Westinghouse
Electric Corporation

AW-95-838

SUBJECT: PRELIMINARY MARKUPS OF AP600 SSAR CHAPTER 15 (ACCIDENT
ANALYSES)

Figure 15.1.2-2

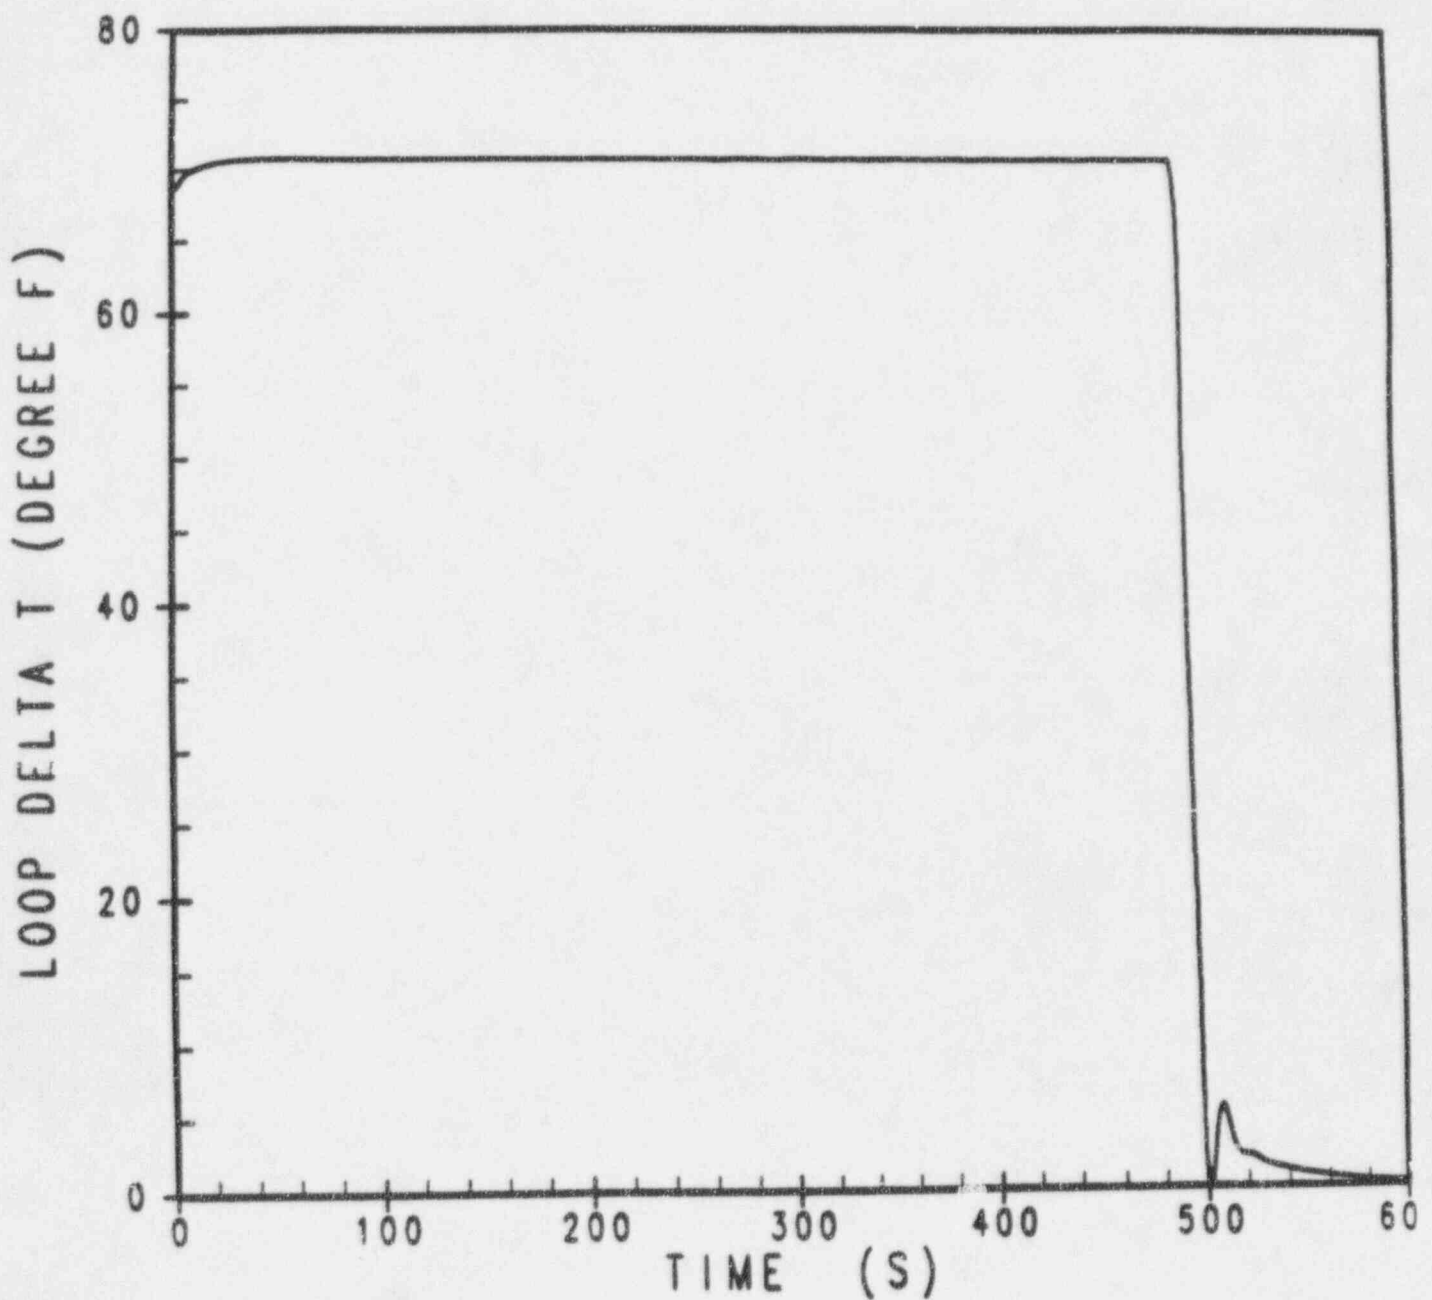
*Replace (next page)
with new*

Figure 15.1.3-9

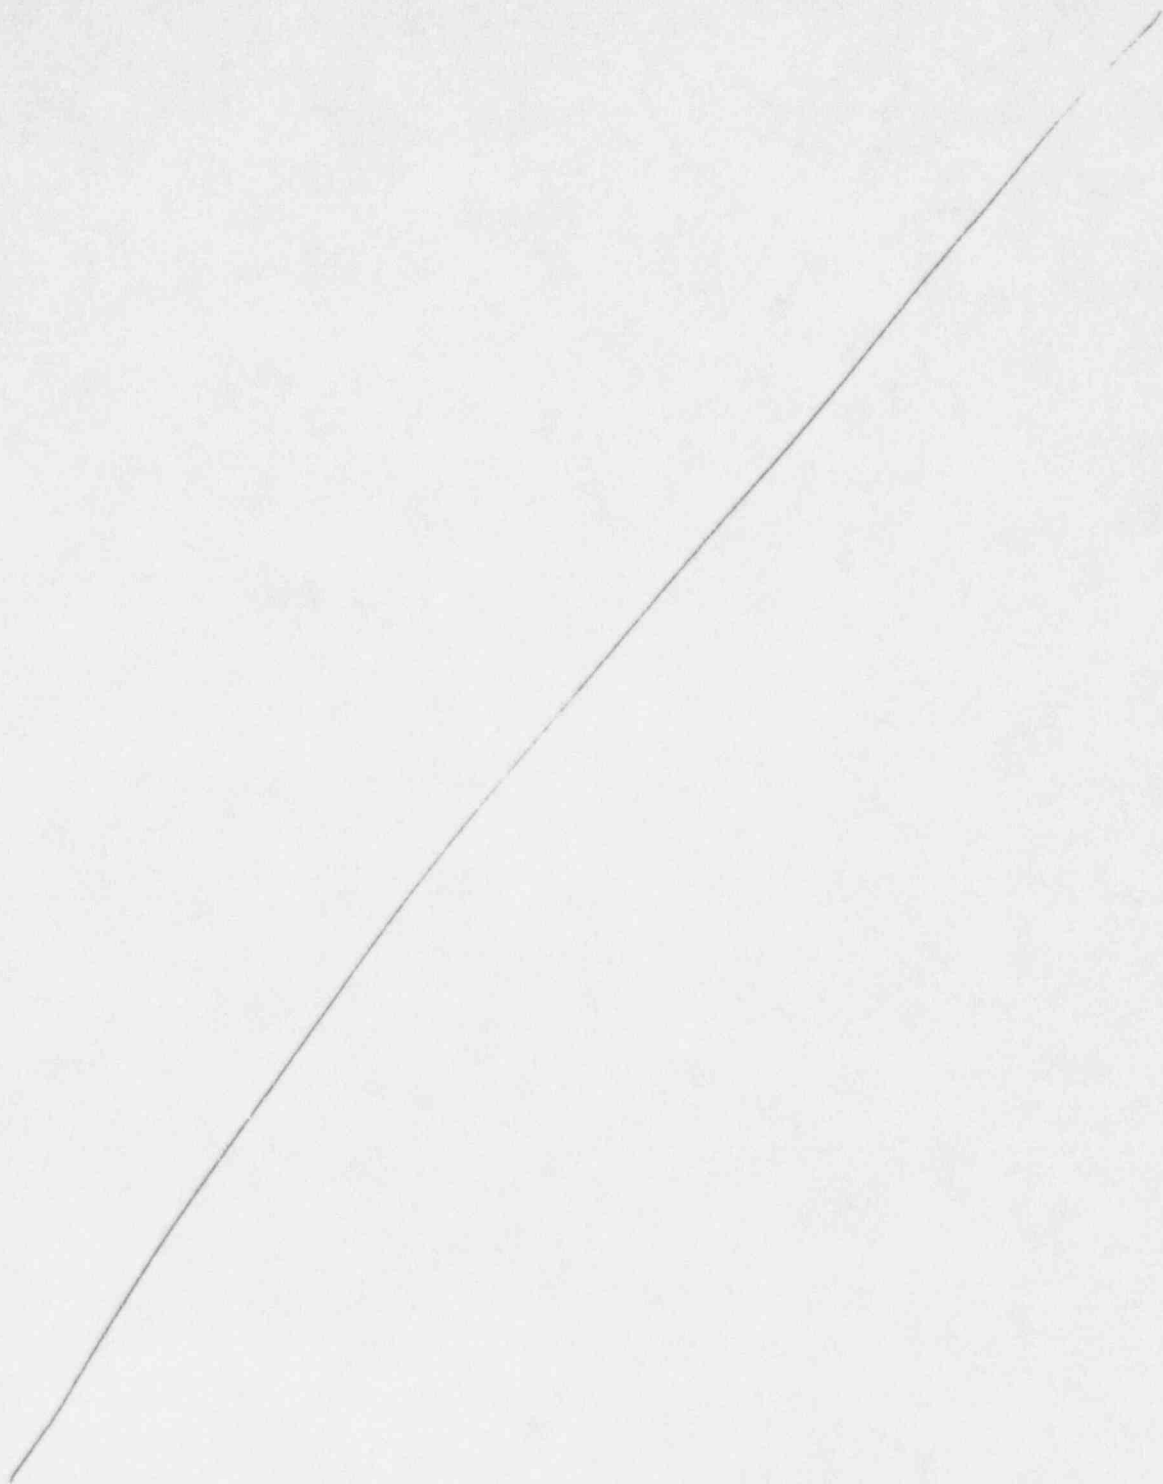
*Replace
(next page)*

Figure 15.2.8-1

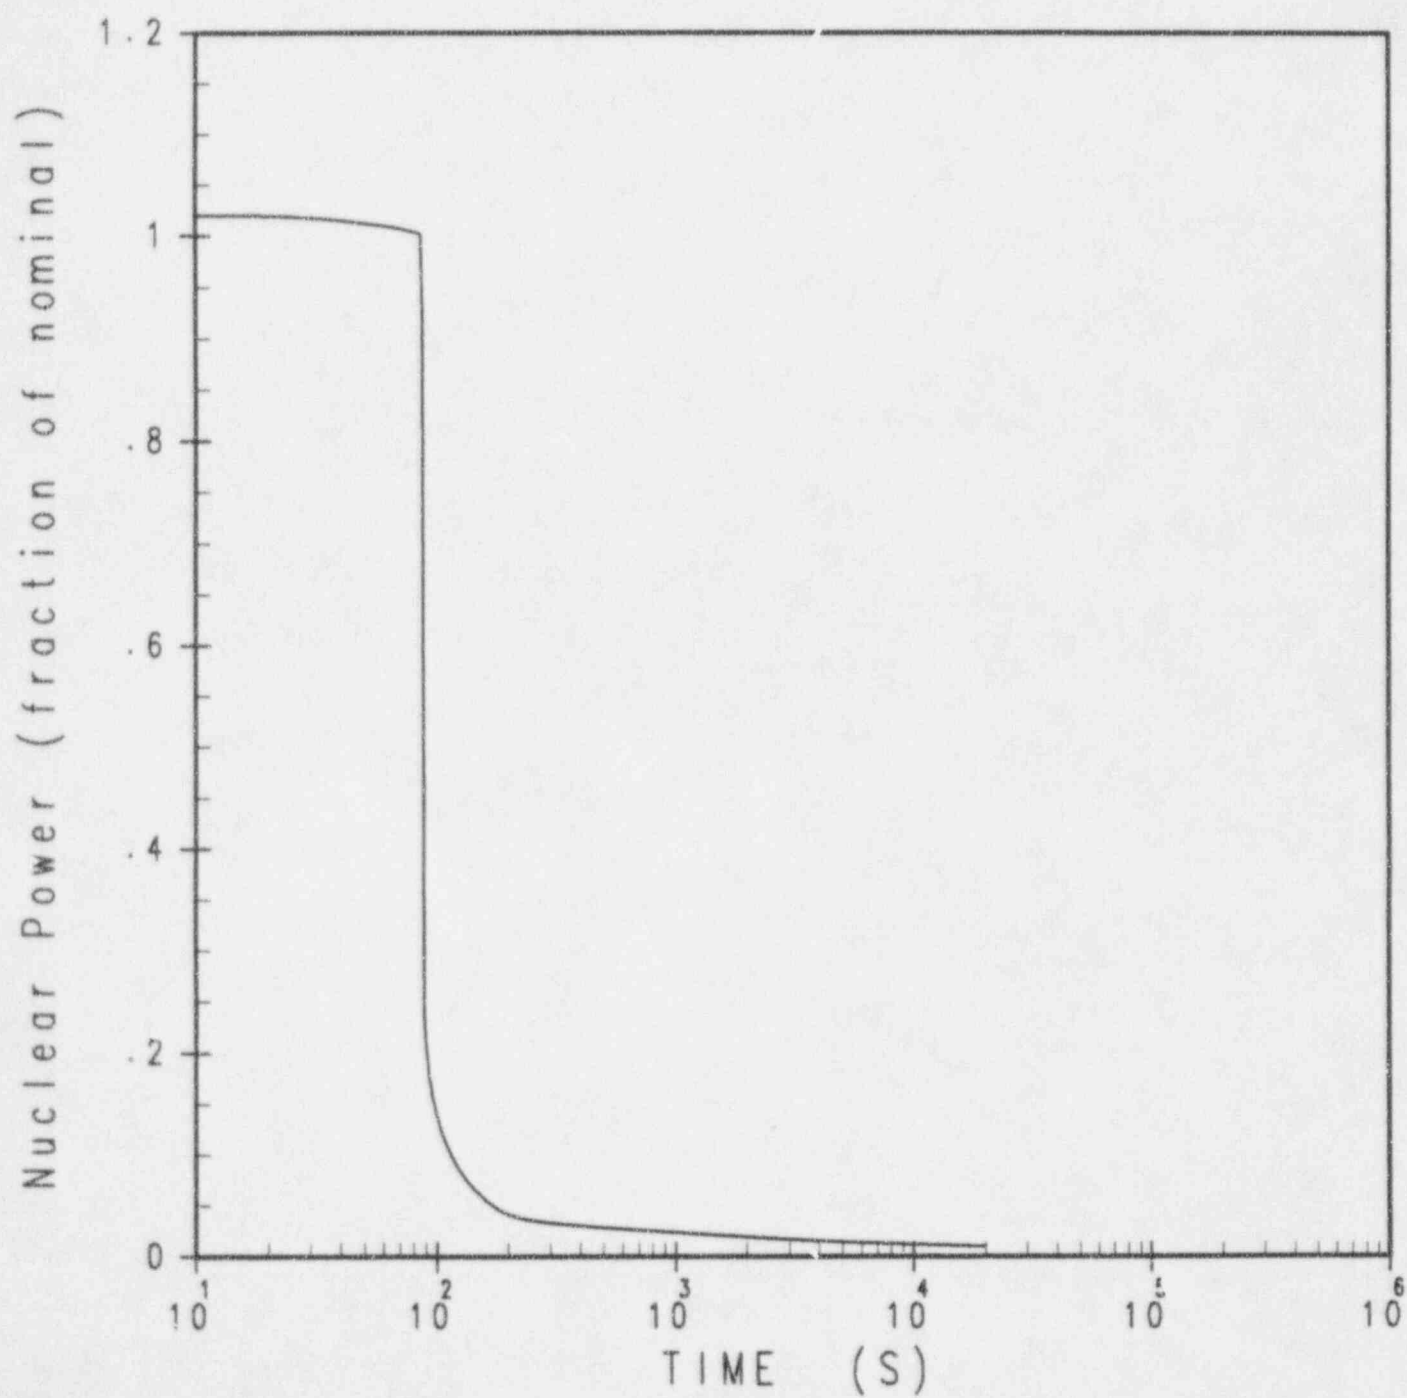
Replace

Figure 15.2.8-8

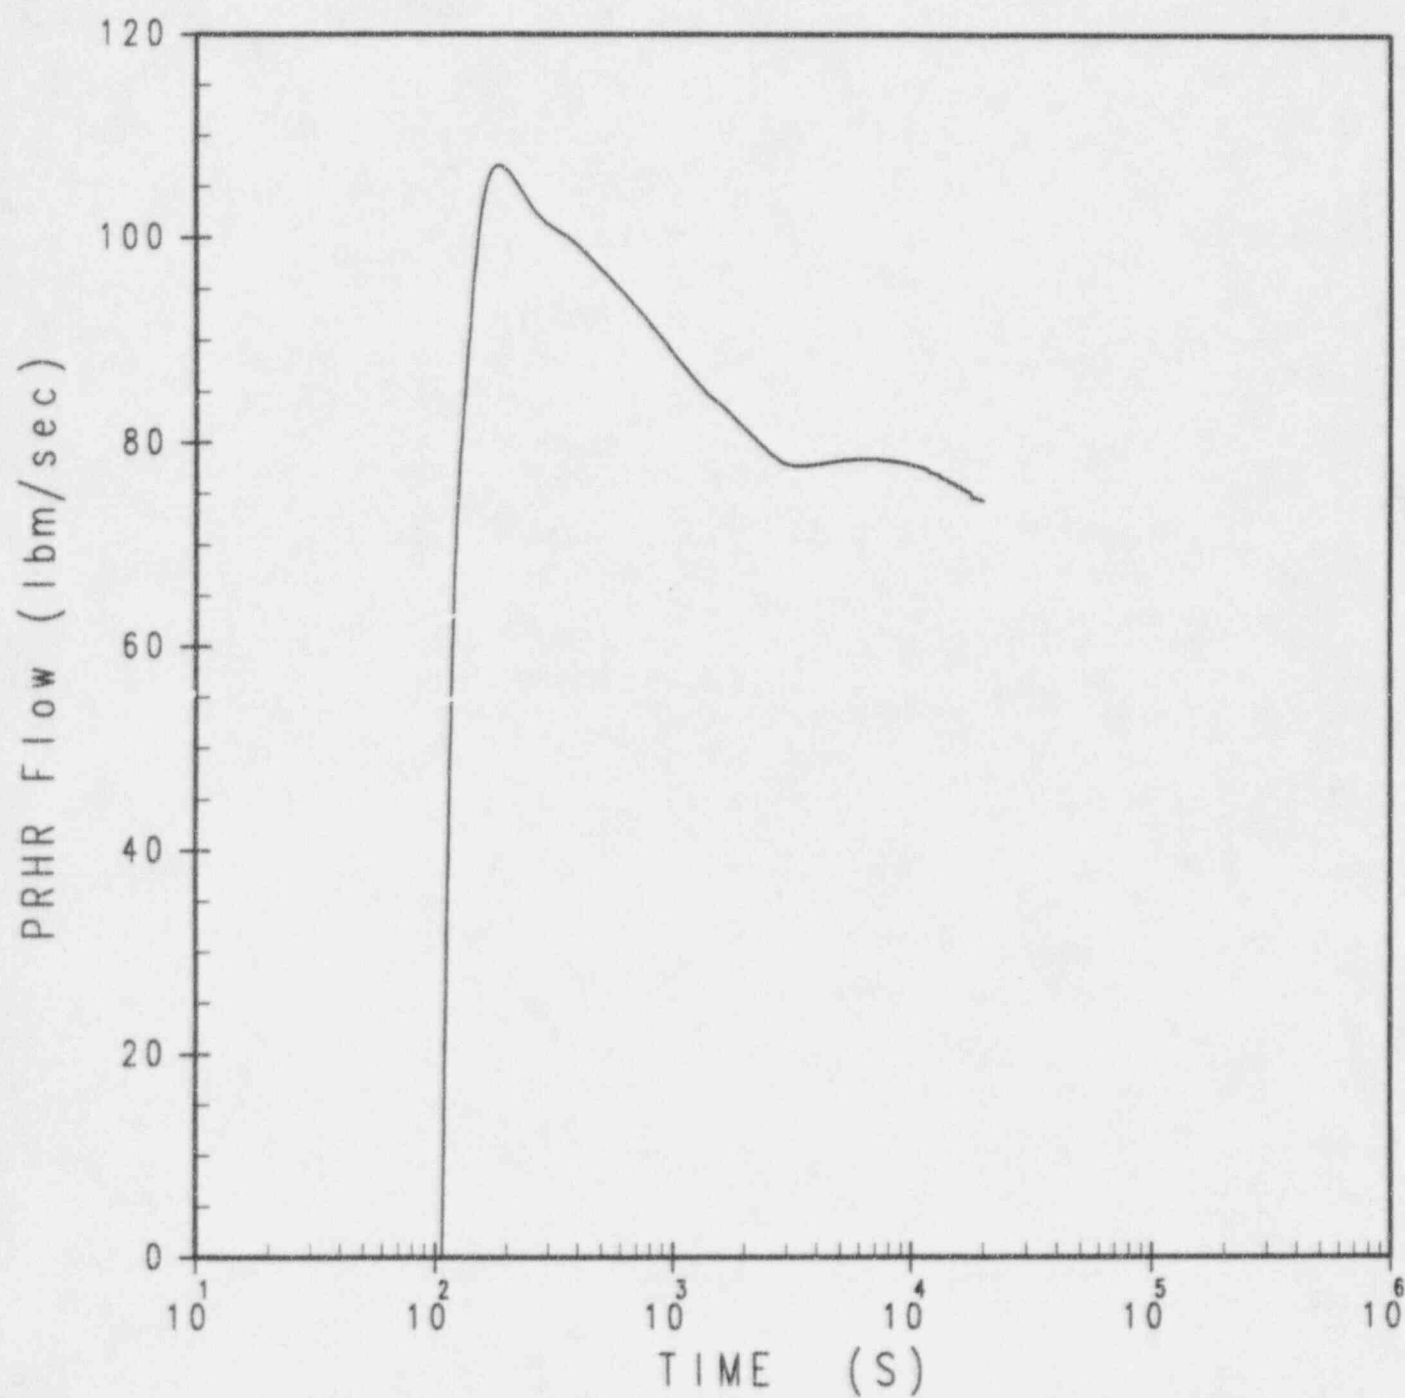
Replace
